APPLICATION NO.	FILING DATE	FIRST NAMED INVENTOR	ATTORNEY DOCKET NO.	CONFIRMATION NO.
10/713,987	11/14/2003	Thomas E. Walker	LK9-03-001	1544
7590 Laurence R. Letson P.O. Box 910567 Lexington, KY 40591			EXAMINER NGUYEN, PHONG H	
			ART UNIT 3724	PAPER NUMBER
DATE MAILED: 02/28/2006

Office Action Summary

DETAILED ACTION

Fig. 3a

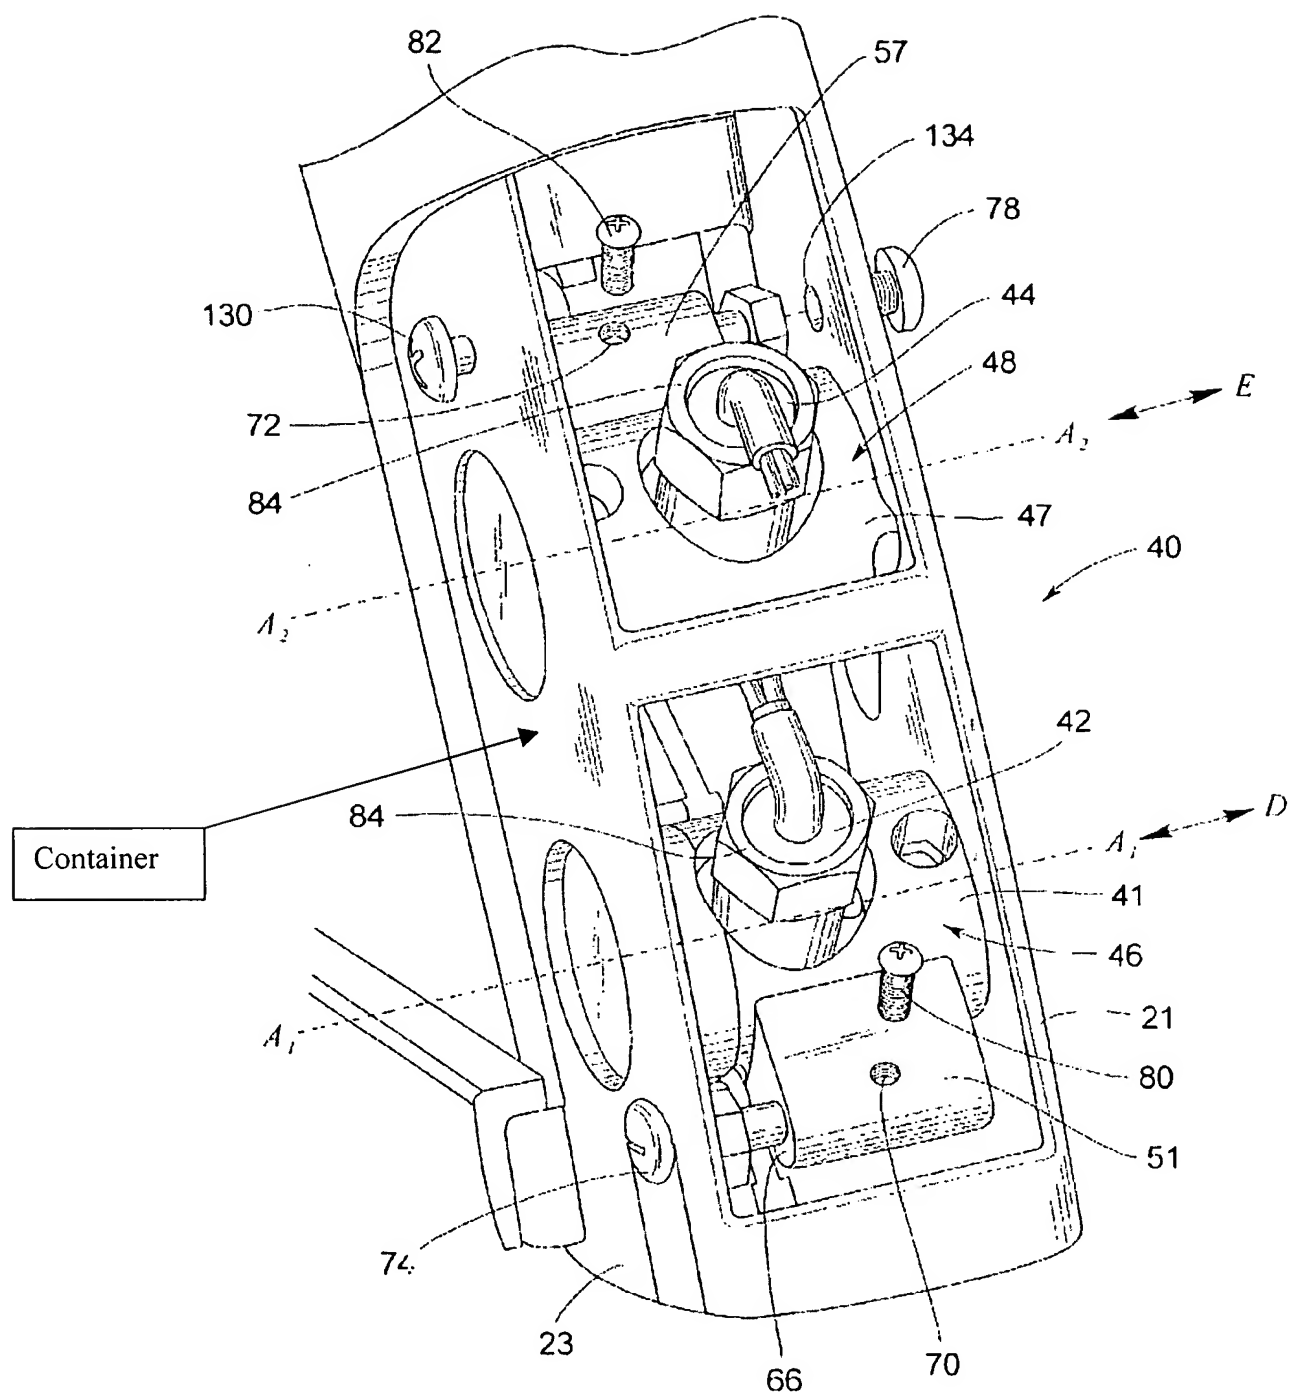
Regarding claims 8-11, the spatial relationship of the container, the screws (78 and 130) and the saw blade is best seen in Figs. 1, 2, 3a, 3b, 5 and 6-9 in Garcia.
